Range SA Large Regional	Model W100	N° T.I. 10_2025
Serial Number 51121274	Subject NEW NON-RETURN VALVE SOLUTION	WITTENBORG

New non return valve solution

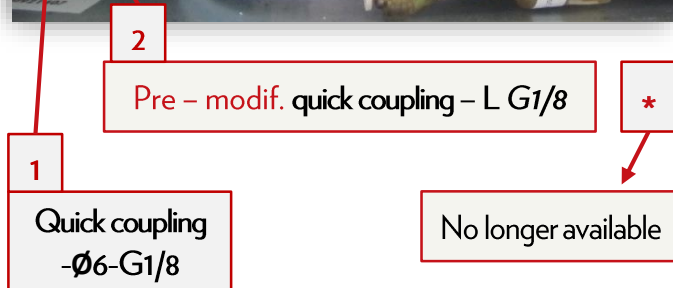
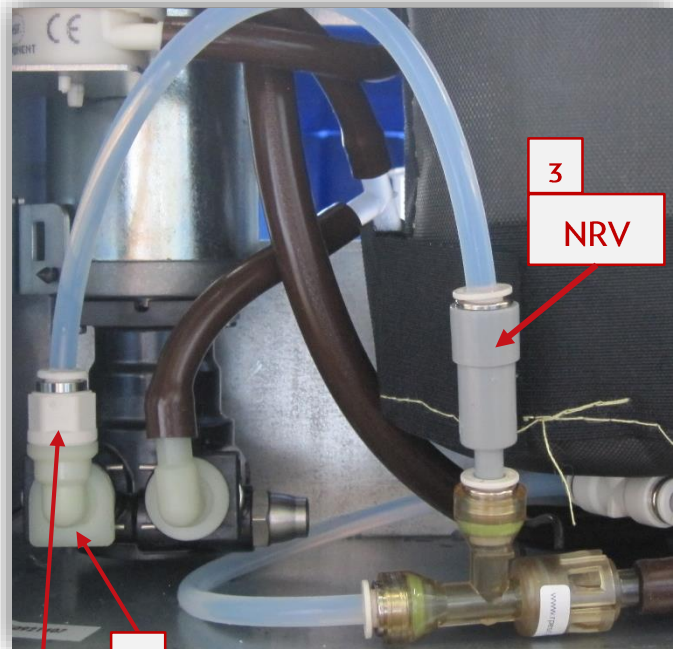
starting from S/N 51121274, machines are equipped with a **new non return valve** solution, which involves the modification of some components; the lengths of the hoses remain unchanged.

The **new non-return valve (3)** is housed in the **modified quick coupling - L G1/4 (2)**

For machines previos to **S/N** above, it is possible to switch to the **new** solution by ordering the *"quick coupling with non-return valve"* KIT (spare code: **267581**), composed of the components listed in the table *"New non-return valve solution"* (see below).
